Water Management Plan for Unconventional Shale Gas Well Development

Big Sewickley Creek – Water Management Plan Amendment Application

May 2, 2023

DETAIL 1
PROPOSED TEMPORARY INTAKE
(BIG SEWICKLEY CREEK)

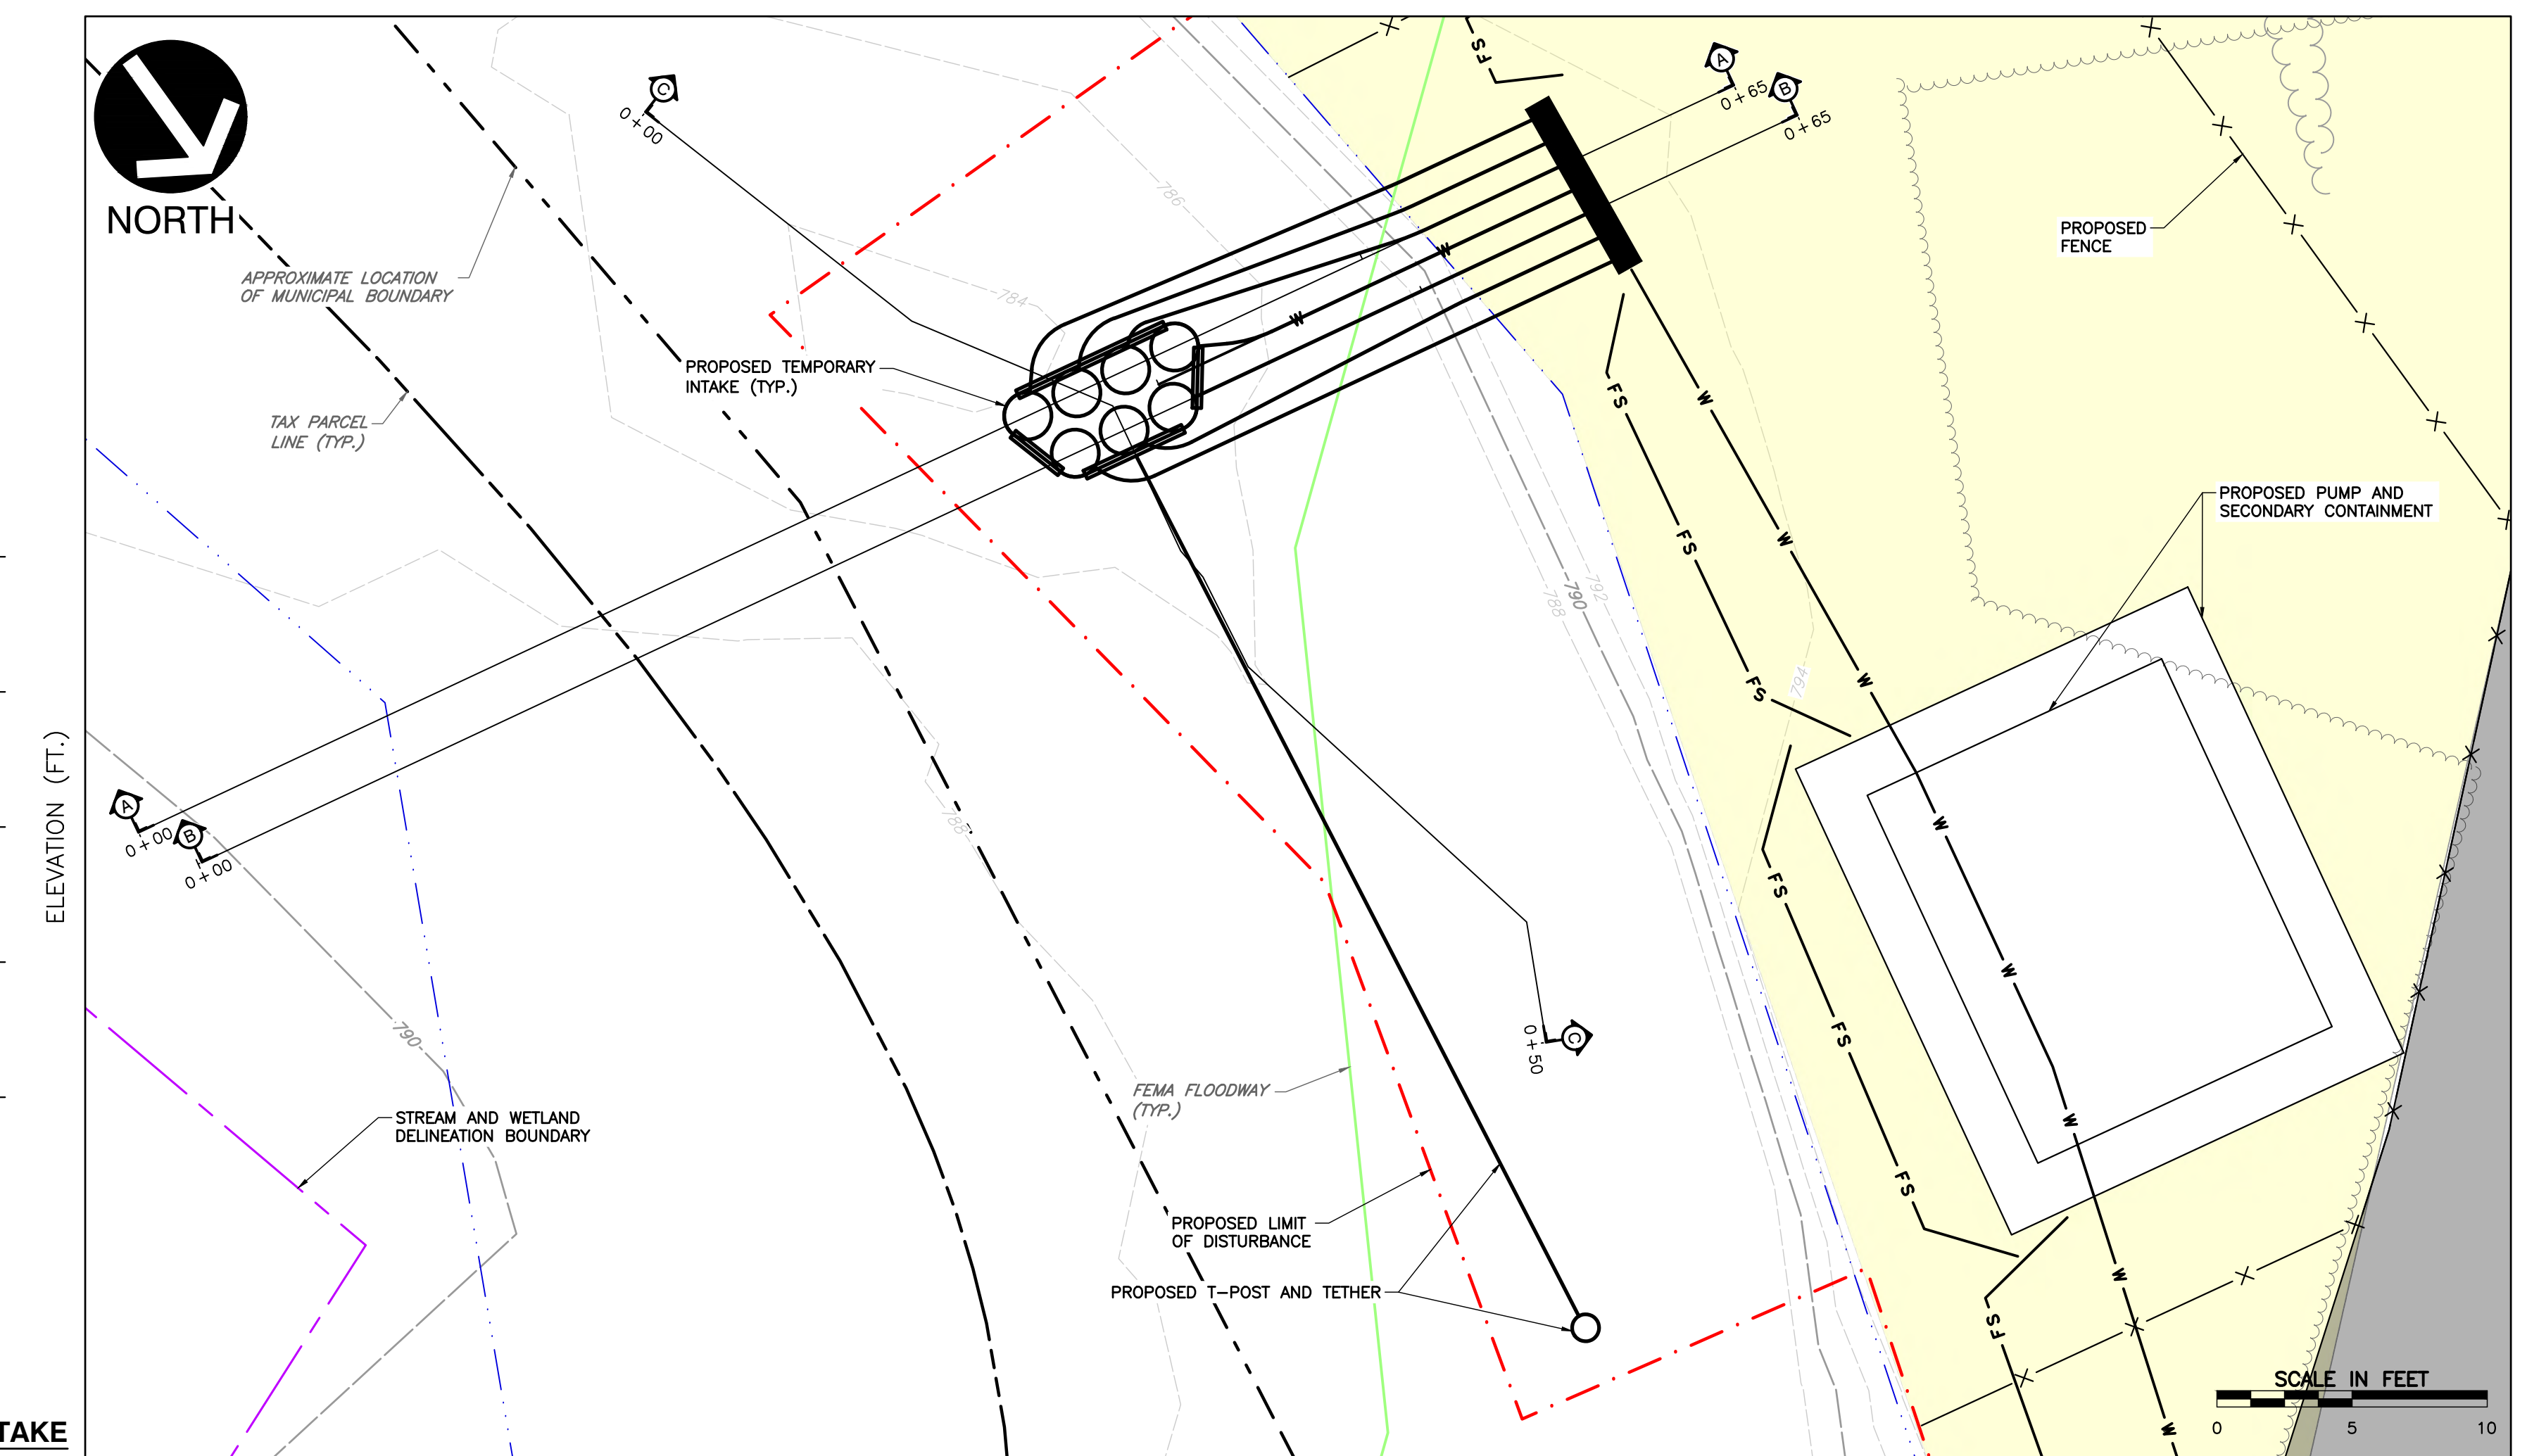
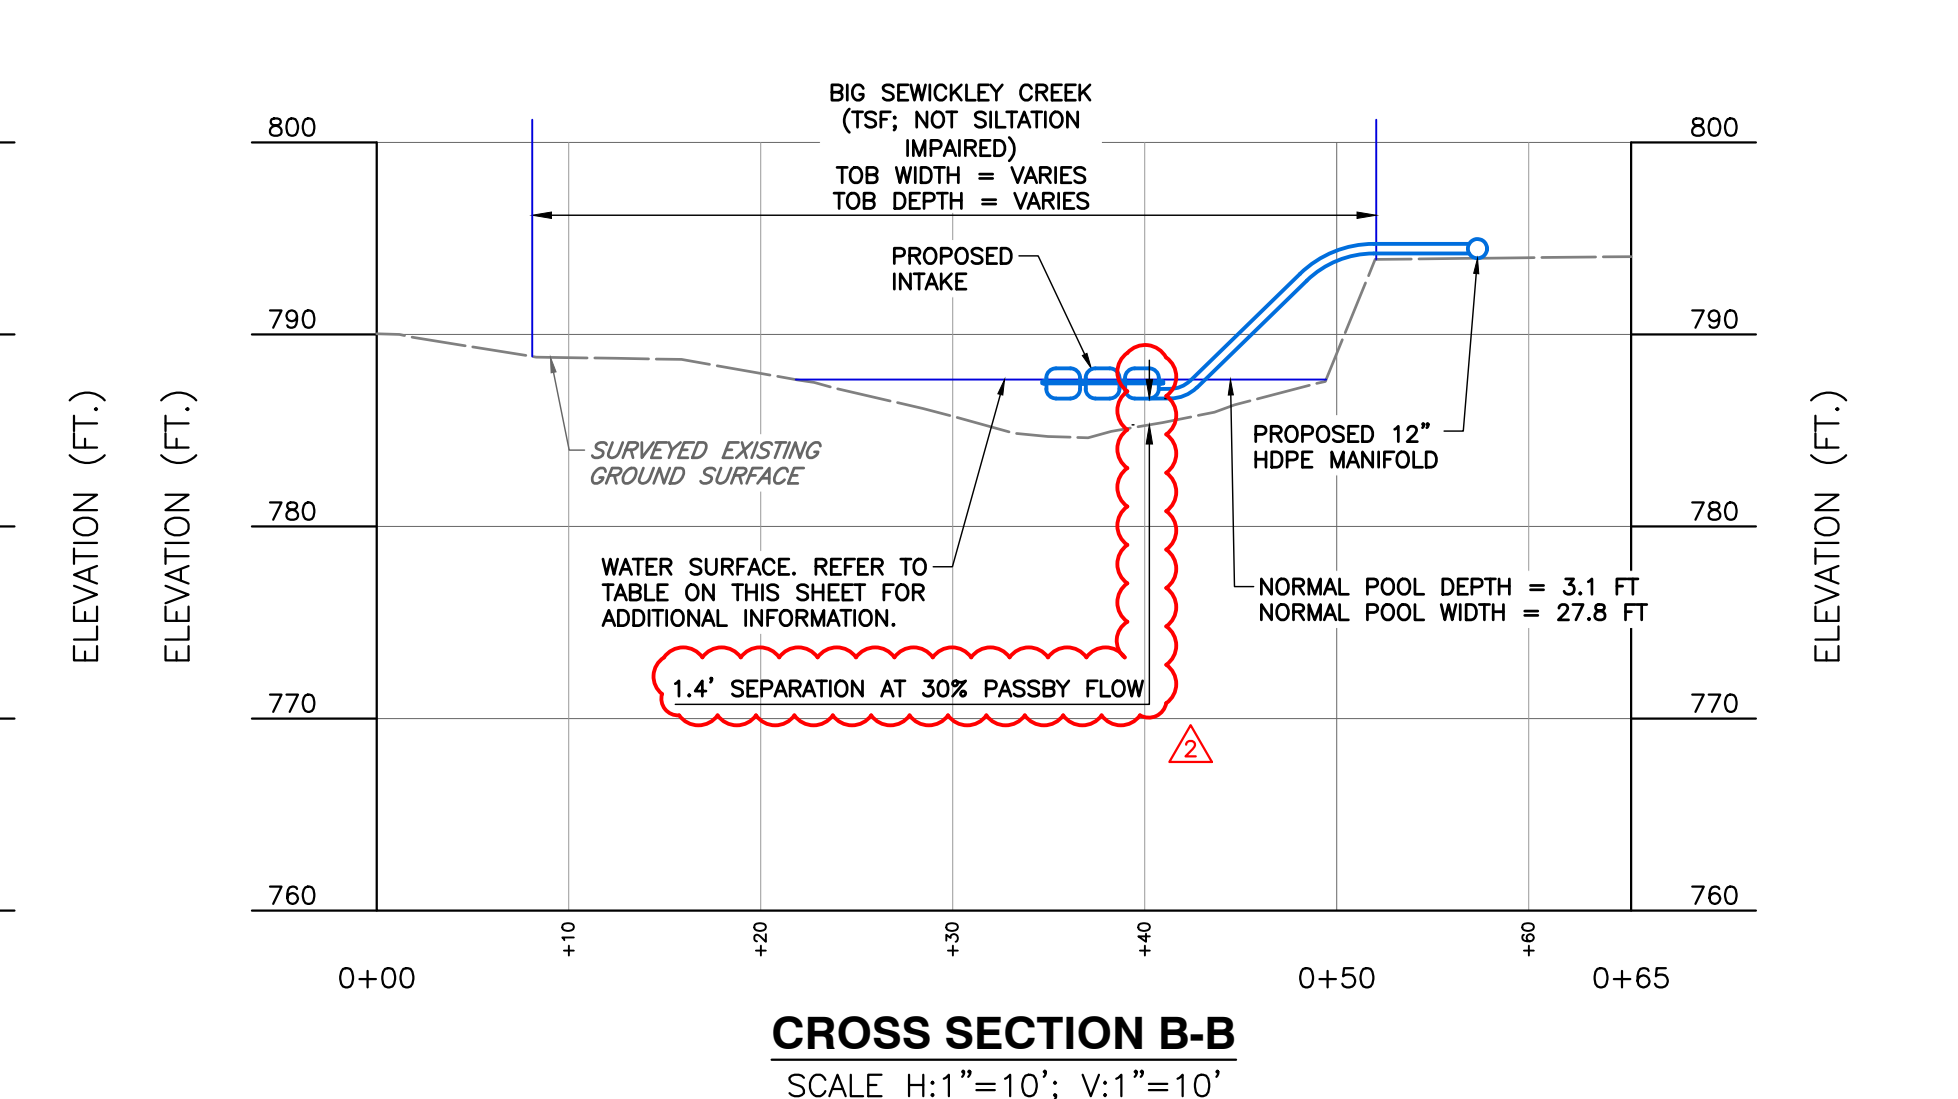
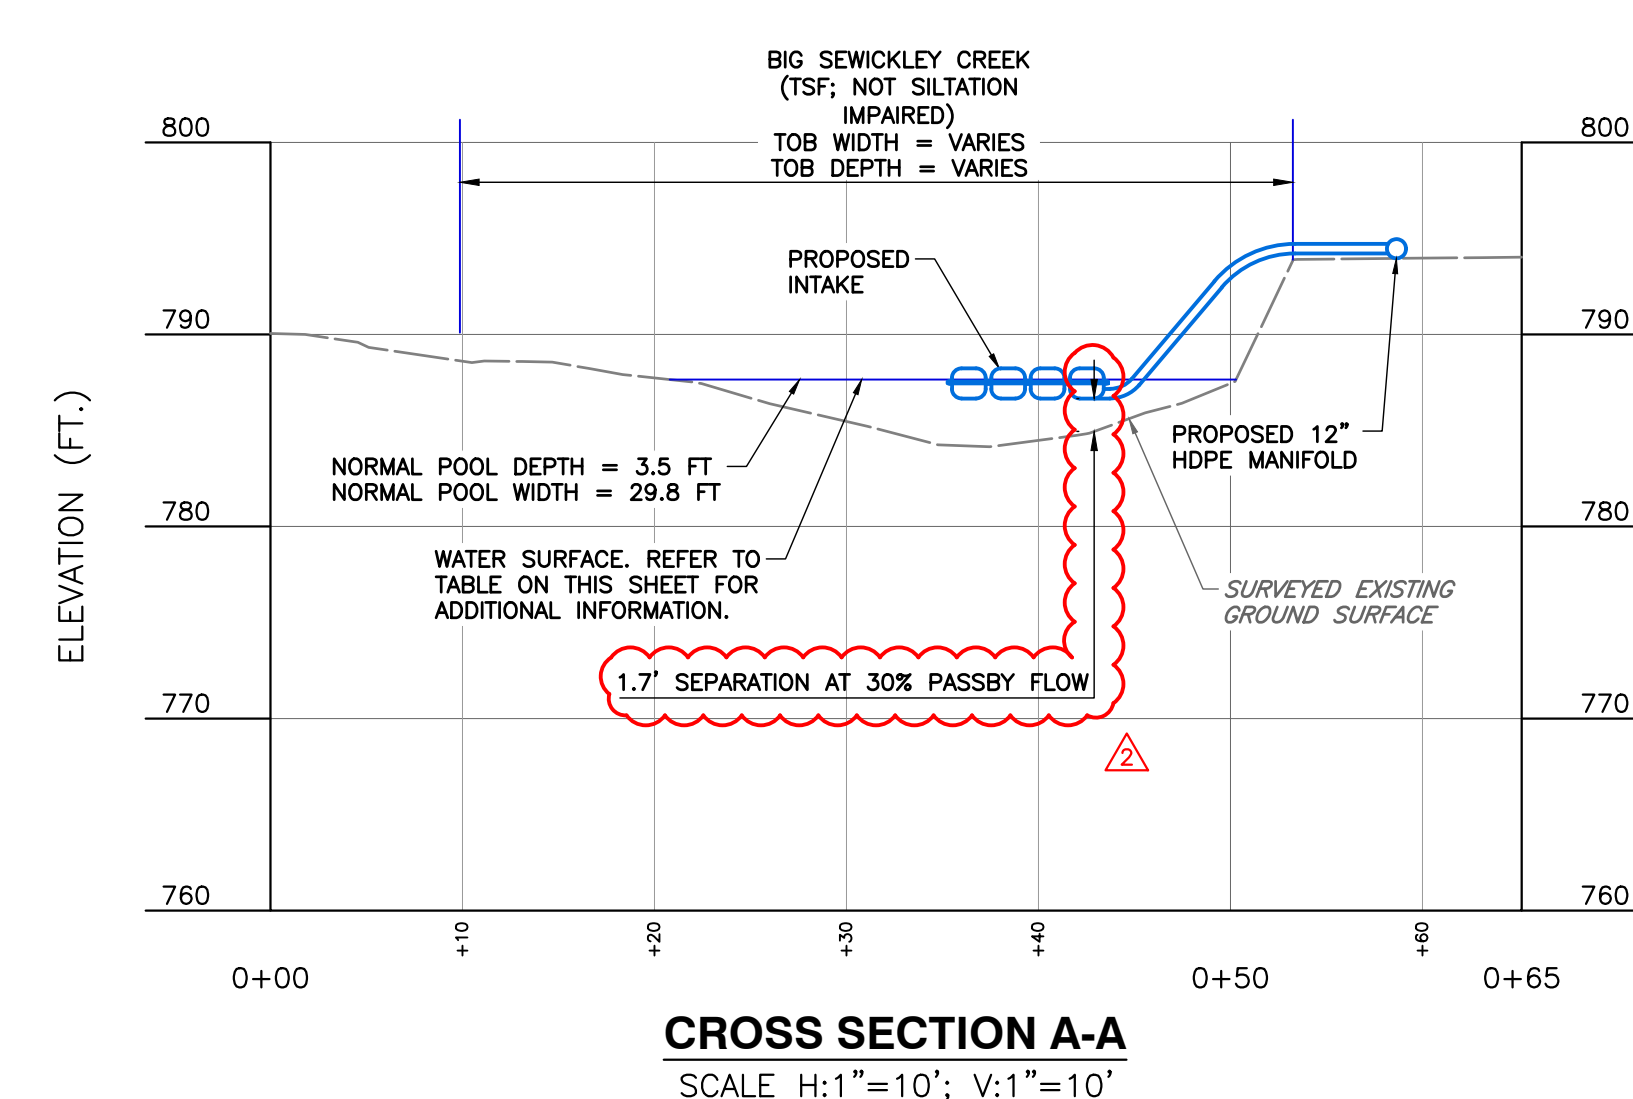
According to the table contained in the notes of Drawing JP01, the water surface elevation of Big Sewickley Creek at the 30% passby flow threshold within the pool the intake will be located in is 787.50'. The surveyed cross sections of the creek (A-A and B-B) indicate the distance from the intake to the stream bottom will be 1.7' and 1.4' respectively at that water surface elevation which is the worst case scenario. Since the intakes were designed according to Commission's recommendation to have a through screen velocity of 0.5 ft/ second or less, I would not think any impacts to the streambed would be expected as a result of the intakes "vacuuming" up sediment in this scenario. The only question that remains, is do you plan to remove the intake raft from the stream when it is not in use? Removing the intake raft when not in use may prevent streambed scour and damage to the equipment from both high and low flow events.

Just left you a voicemail about the wording in the comment and concerns that your email might not fully address what Ms. Lutz is looking for. The comment specifically mentions not causing disturbance to the stream bed – most notably 1.e. and 1.f. below. Do you have enough information to make the statement that the withdrawal as designed will prevent impingement and entrainment AND is of sufficient depth for a withdrawal to occur with no disturbance to the stream bed?

- a. Provide the surveyed ground (stream bed bottom) elevation of Big Sewickley Creek at the proposed withdrawal location.
 - b. Provide a justification that the delineated max pool depth is an adequate representative of the normal pool depth of Big Sewickley Creek. The actual normal pool depth should be reflected.

- c. In addition to the normal pool depth, update Cross-section A-A to show the water elevations associated with the required flow rates (i.e. 8.8 and 13.1 cfs) for the full withdrawal rate to occur.

- d. Show the actual dimensions of the dolphin intake(s) that will be utilized during withdrawals.
 - e. Document that the water elevations at various flows is of sufficient depth for a withdrawal to **occur without stream bed disturbance**. Specifically, the

- f. Provide a stream profile through each of the seven (7) intake structure locations clearly depicting that each individual intake structure is suspended at a sufficient depth for a withdrawal to occur and that no streambed impacts will occur.

27, 2022, when water levels present at the withdrawal location were stated to only be six inches; that the cross-section of Big Sewickley is changing, and that there may be times that the proposed floating intake exceeds the depth of water of Big Sewickley Creek. Please evaluate the notations of the PBFC in your analysis and when updating the Operations Plan intake profile.

REVISION RECORD		
NO	DATE	DESCRIPTION
1	02/28/2023	REVISED IN ACCORDANCE WITH THE 12/23/2022 PADEP CORRECTION NOTICE
2	04/24/2023	REVISED PER ESCOP-3 (4/6/23), JPA (4/19/23), AND WMP (4/19/23) COMMENTS

I have reviewed the revised plans you and Dakota discussed last week concerning meeting the Commission's recommendations for water depth when citing floating surface water intakes. Reorienting the intake "raft" to be perpendicular to flow along its longest access shifts it slightly down stream into deeper water as per the Stream Bed Profile (H-H). This change increases the water depth from your initial proposal to a minimum of 2.8 feet at a normal pool elevation of 787.68'. This change alleviates our concern for the impingement and entrainment of aquatic life resolving any outstanding coordination for threatened or endangered species with the Commission. Please note that I have copied the Samantha Lutz of the Departments Southwest Regional Office to make her aware of our coordination. Thank you for your consideration and let me know if you have any questions.

As discussed last week, attached is the updated site plan and cross sections for PennEnergy's proposed Big Sewickley Creek for your review. The strainer intake orientation, cross sections, and pool elevation have been revised. Please let me know if you have any questions or need anything further for your review.
